SERVICE BULLETIN

No. SB-AG-56

Revision B: 12/10/2020

S2R-H80 AFT LOWER COWL MODIFICATION

Figure 8-2
Engine Mount Weld Lug
Locations

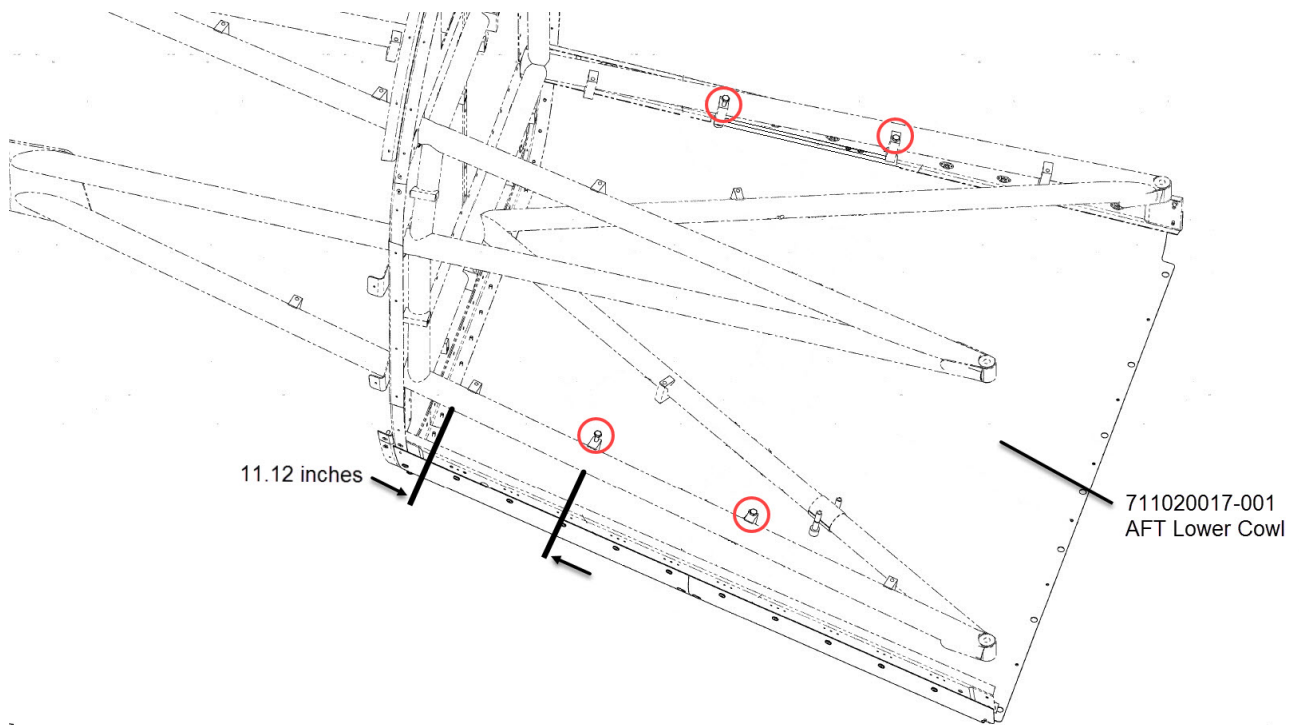
- B. Remove and discard (2) AN4-24A and (2) AN4-30A bolts and associated (4) AN960-416 washers and (4) MS21033N4 nuts at engine mount weld lugs that attach to the baggage compartment and battery plate located 11.12 inches from FWD firewall. See Figure 8-2.

Figure 8-3
Channel Assembly

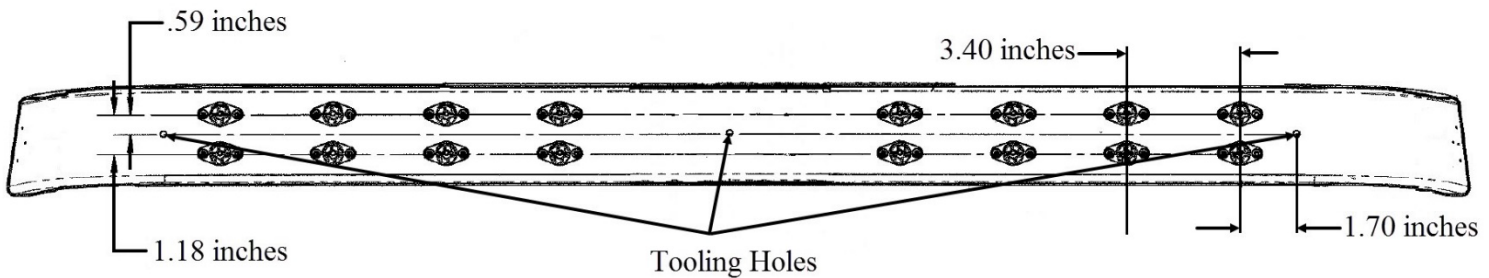
- C. Layout Camloc pilot hole locations in Channel Assembly 711020069 using dimensions as shown in Fig. 8-3. Drill (20) .128" dia. for Camloc pilot hole. Drill & countersink (32) .128" dia. into channel to match Camloc fastening holes. Install with MS20426AD4 rivets.

Figure 8-4
Location for Drill

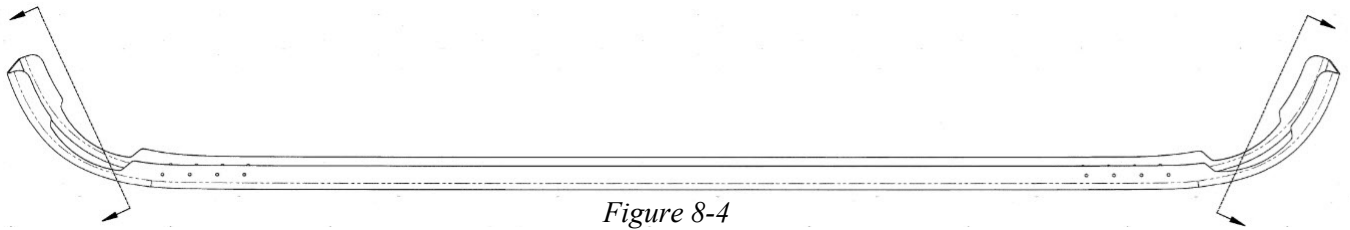
- D. Drill (6) .098" dia. pilot holes for Formed Clip and (4) .128" dia. pilot holes for (4) Camlocs as shown in Figures 8-4 & 8-5.

Figure 8-6
Cowl Support Angle & Channel Support Bracket
Assembly

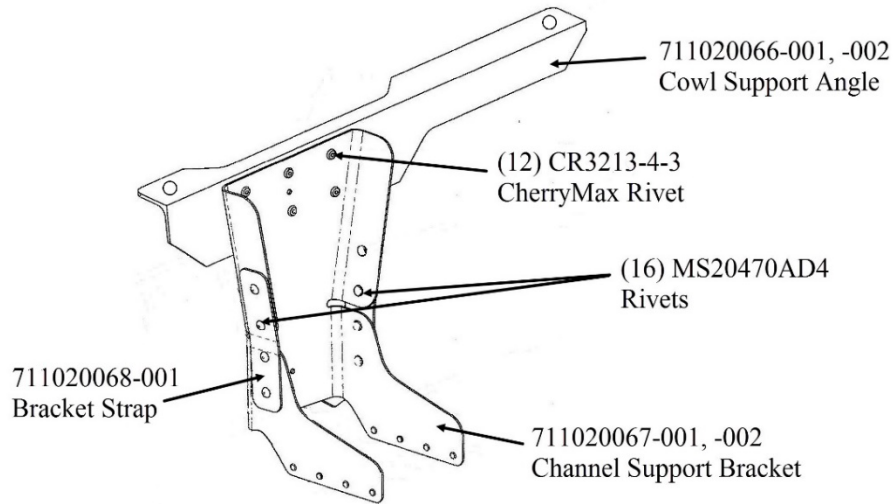
- E. Assemble (2) Cowl Support Angle, (2) Channel Support Bracket, and (4) Bracket Straps by stepping up all pilot holes to .128" dia. Assemble using hardware in Figure 8-6.

Figure 8-7
Cowl Support Assembly Installation

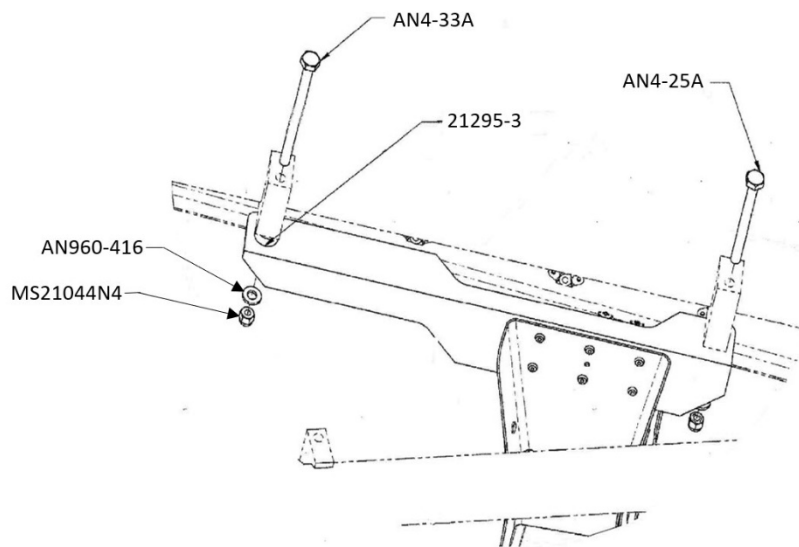
- G. Install (2) AN4-25A AFT bolts and (2) AN4-33A FWD bolts. Assemble (4) 21295-3 spacers (one each side of FWD bolt and nut) as shown between weld lug and cowl support angle 711020066. Hand tighten all bolts using (4) AN960-416 washers and (4) MS21044N4 nuts. See Figures 8-7 & 8-8.

*Figure 8-9
Aligned Channel Assembly
*Clamped in place for Reference**

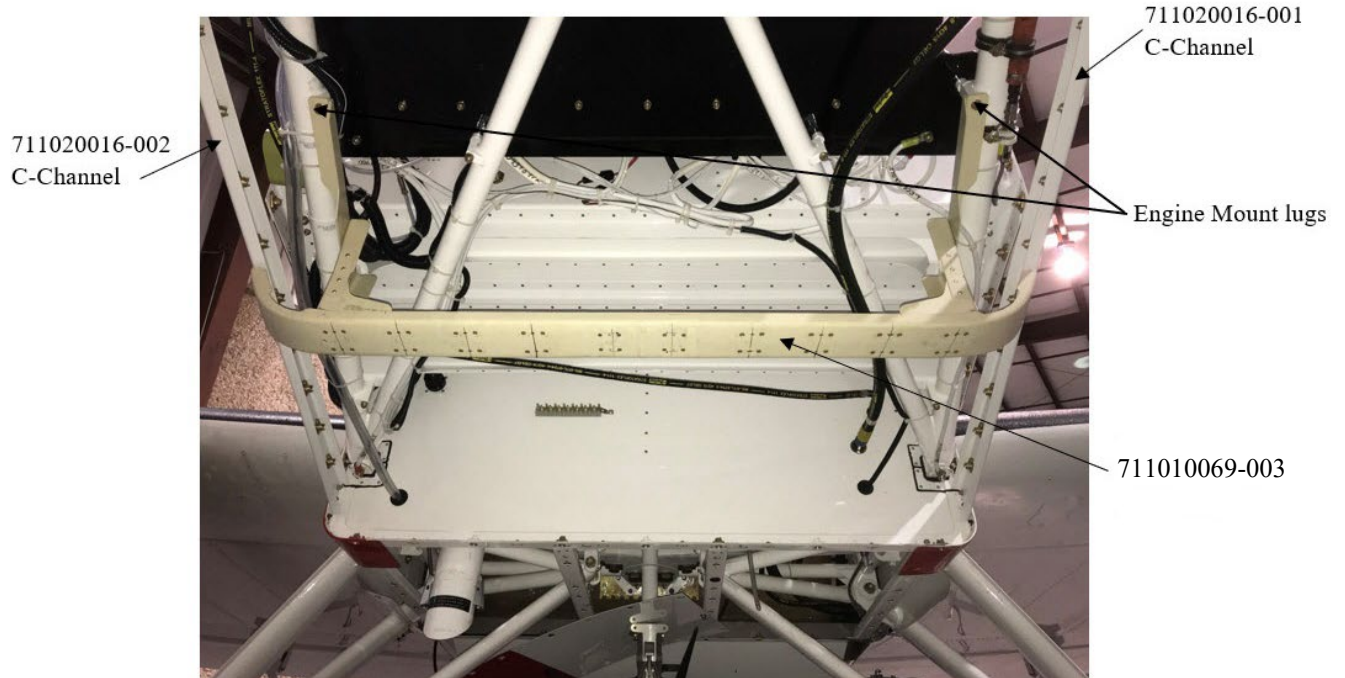
H. Locate and center Channel Assembly 711010069 in relation to C- Channels and Channel Support Bracket. See Figure 8-9.

*Figure 8-10
Doubler Installation in Channel
Assembly*

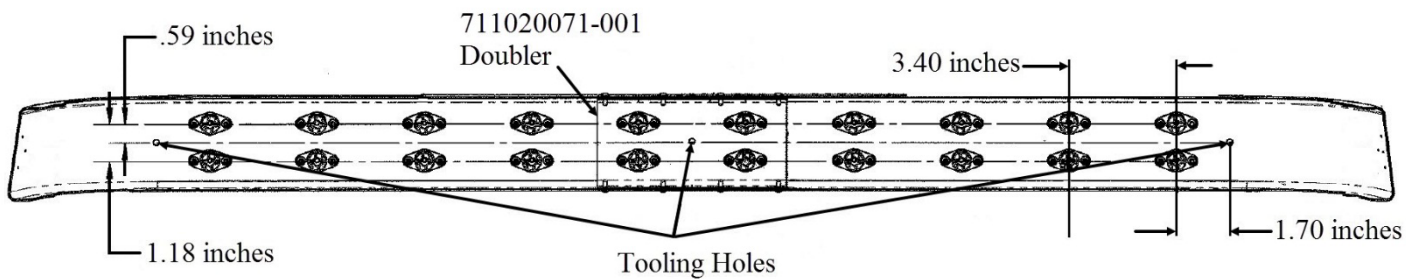
I. Install Doubler 711020071 to Channel Assembly as shown in Figure 8-10.

*Figure 8-11
Pilot Hole Location*

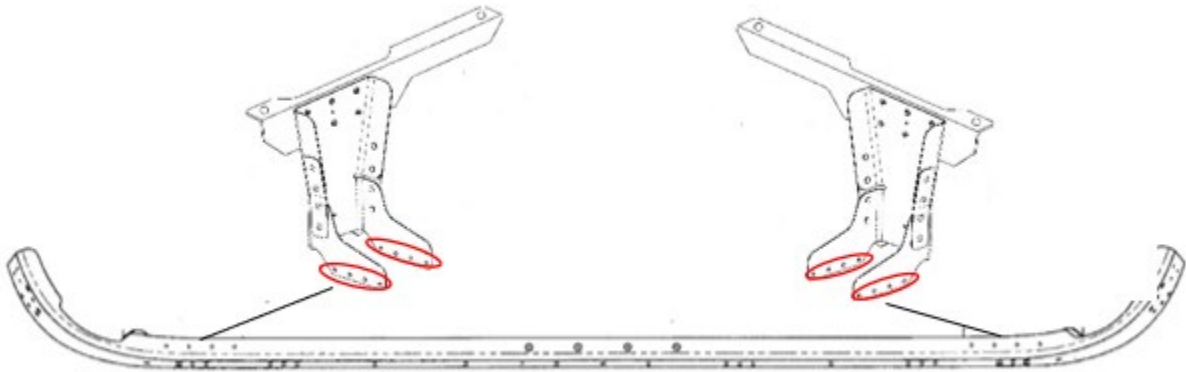
- J. Clamp Channel Assembly to Channel Support Bracket. Drill (16) .128" dia. through support bracket pilot holes into channel assy. Temporarily fasten in place. See Figure 8-11.

*Figure 8-12
Outboard side of Cowl Support
Assembly installed in aircraft*

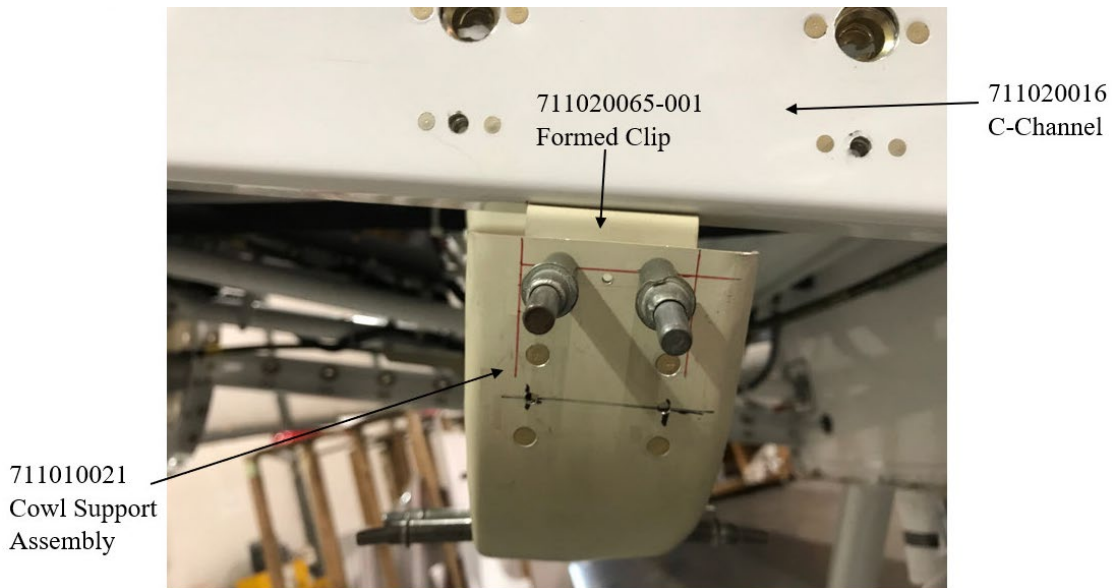
- K. Clamp Formed Clip 711020065-001 with Channel Assembly and C-Channel. Use pilot holes in Channel Assembly to drill (6) .098" dia. holes through Formed Clip. Temporarily fasten. See Figure 8-12.

Figure 8-13
Within aircraft frame looking FWD

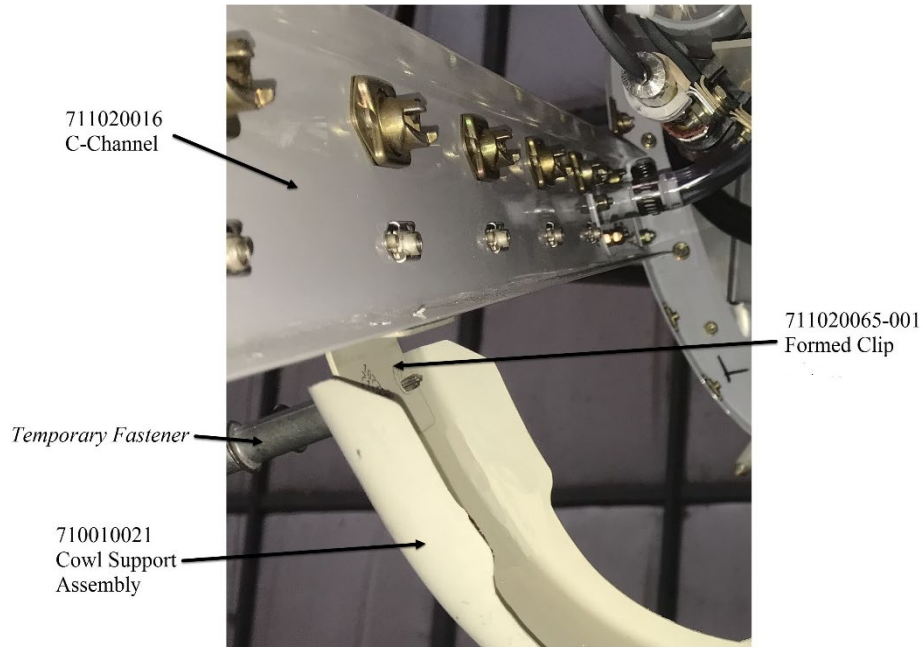
- L. Temporarily fasten Formed Clip into C-Channel. Drill (4) .166" dia. holes through Formed Clip pilot holes into C-Channel. See Figure 8-13.

Figure 8-17
Camloc Installation

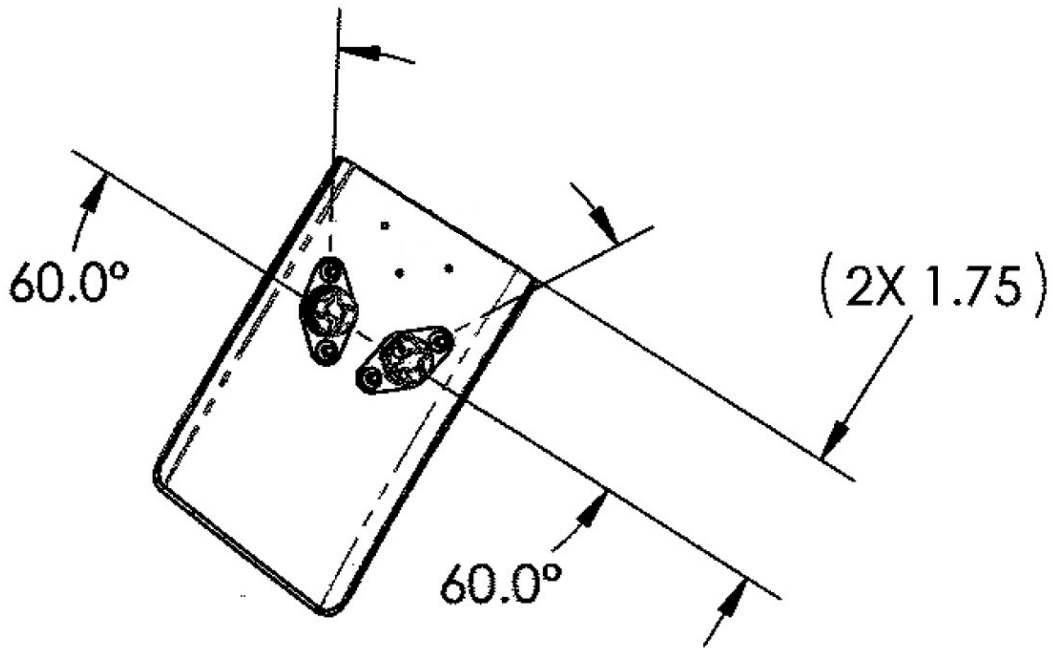
P. Install (4) Camlocs to Channel Assembly as shown in Figure 8-17.

Figure 8-18
Channel Assembly to Channel Support
Bracket Installation

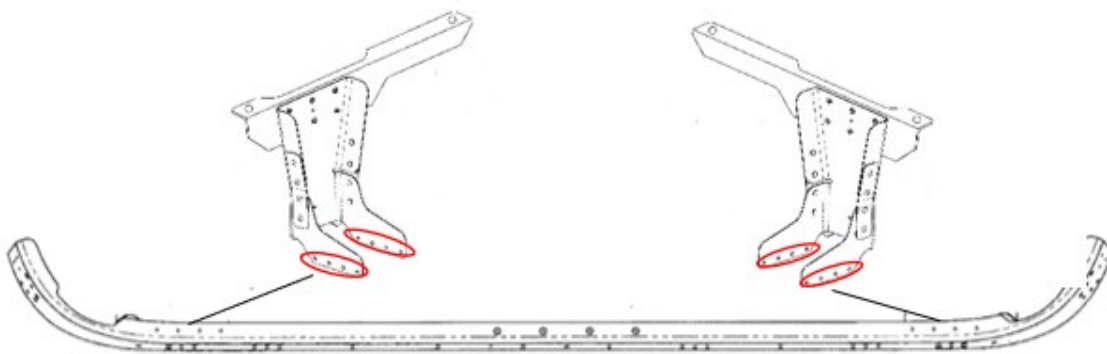
Q. Install Channel Support Brackets to Channel Assembly using MS20470AD4 rivets.
See Figure 8-18.

*Figure 8-19
Pilot hole location on Cowl Support Assembly
View from under aircraft*

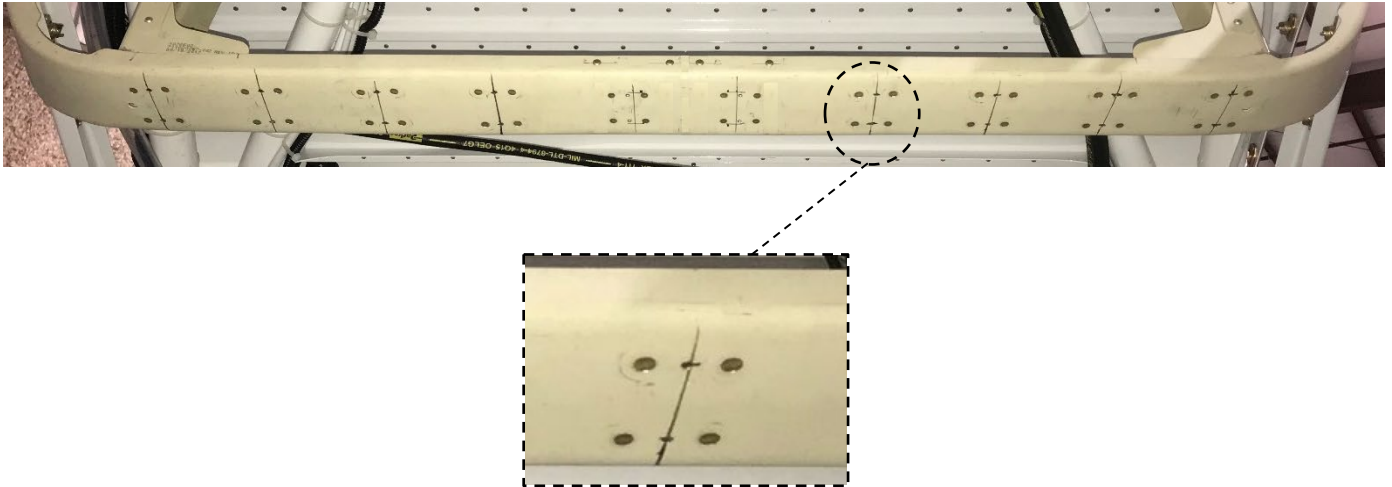
- R. Use a .625" hole cutter and cut through (24) Camloc pilot holes in Cowl Support Assembly.
See Figure 8-19.

DO NOT CUT INTO CAMLOC WHILE ENLARGING PILOT HOLES

Figure 8-21
Forward Cowl Skin Assembly

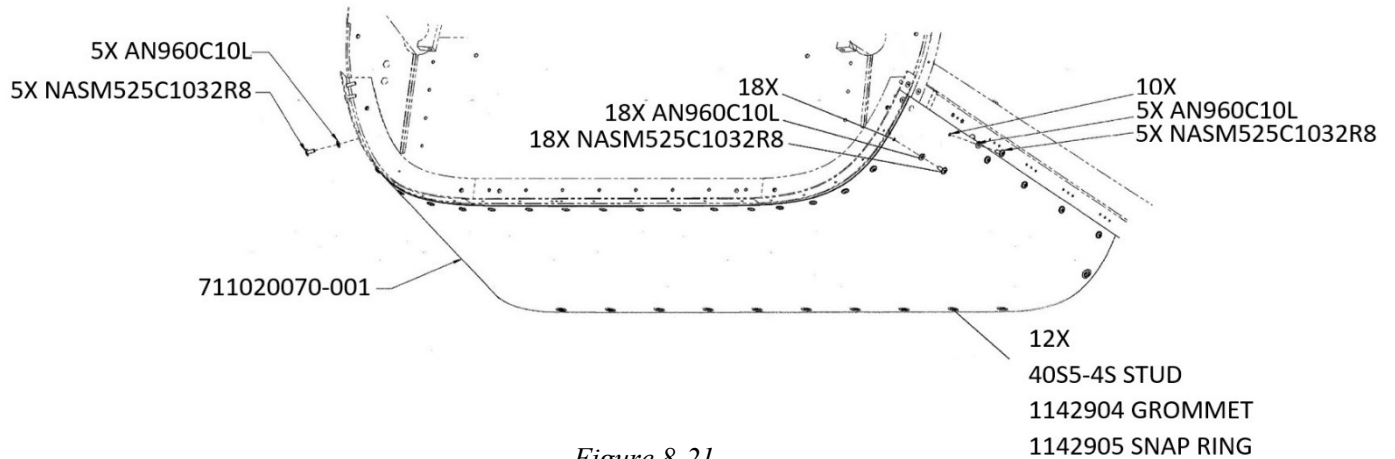
- T. Prepare FWD Cowl Skin 711020070-001 for installation. See Figure 8-21.
- Match drill (28) .1935" dia. holes at FWD firewall lower frame existing holes and C-Channel nutplate locations.
 - Match drill (12) (12mm) .471" dia. holes at Cowl Support Assembly Camloc locations.

Figure 8-22
AFT Cowl Skin Assembly

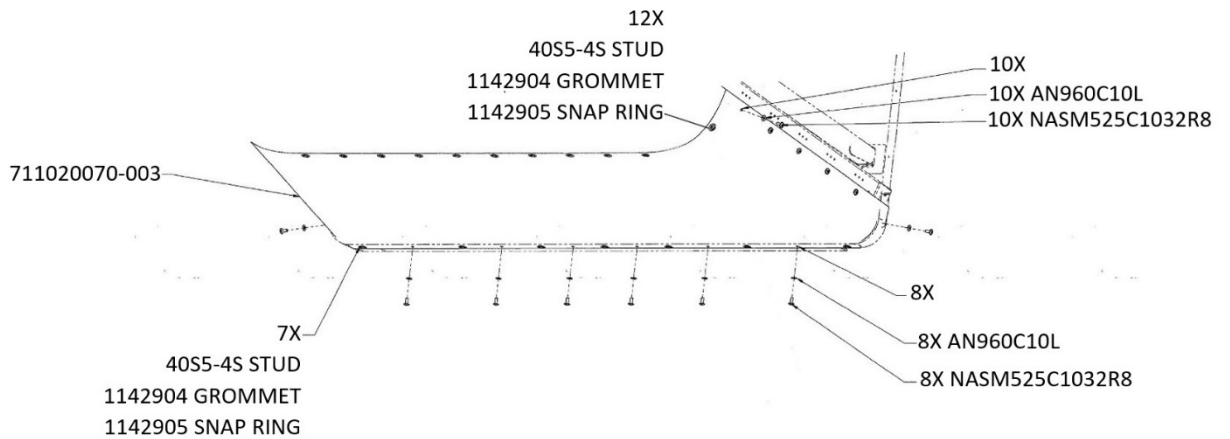
- U. Prepare AFT Cowl Skin 711020070-003 for installation. See Figure 8-22.
- Match drill (18) .1935" dia. holes at AFT firewall and C-Channel nutplate locations.
 - Match drill (19) (12mm) .471" dia. holes at Cowl Support Assembly Camloc locations and AFT Firewall locations.
